MEMORANDUM

Subject: DWR Responses to Questions from DMS regarding implementation of the Consolidated Buffer Mitigation Rule [15A NCAC 02B .0295]

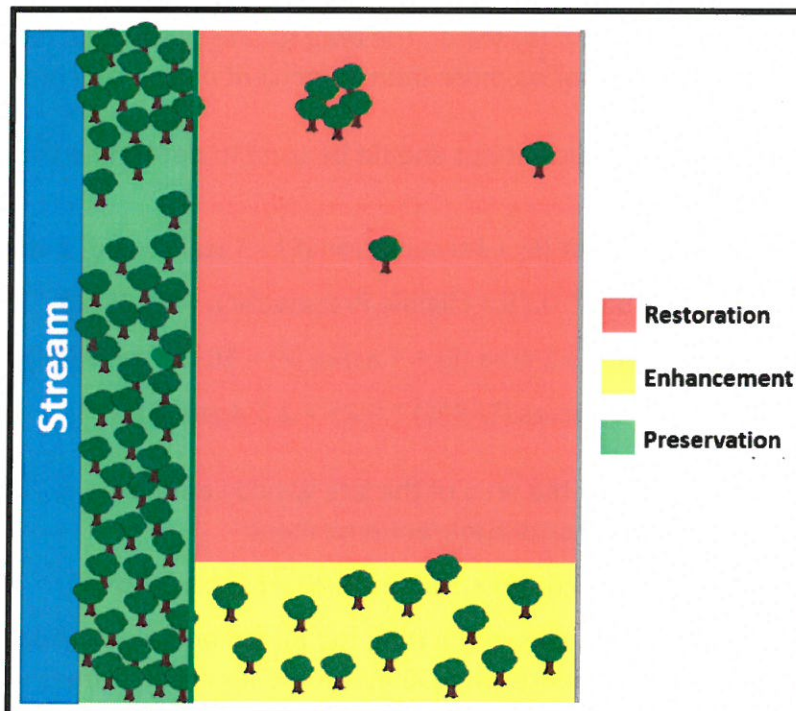
DMS asked for clarification on how DWR defines the breaks between restoration¹ and enhancement². Specifically, DMS asked whether drip lines were still used and whether individual trees were excluded from restoration sites.

DWR has not considered the drip line to represent the outer edge of a wooded area for several years. This was clarified in a memo from DWR to DMS in August 2013. Individual trees do not need to be delineated and removed from the restoration area, rather DWR looks for areas or zones when determining restoration, enhancement or preservation areas. For example:
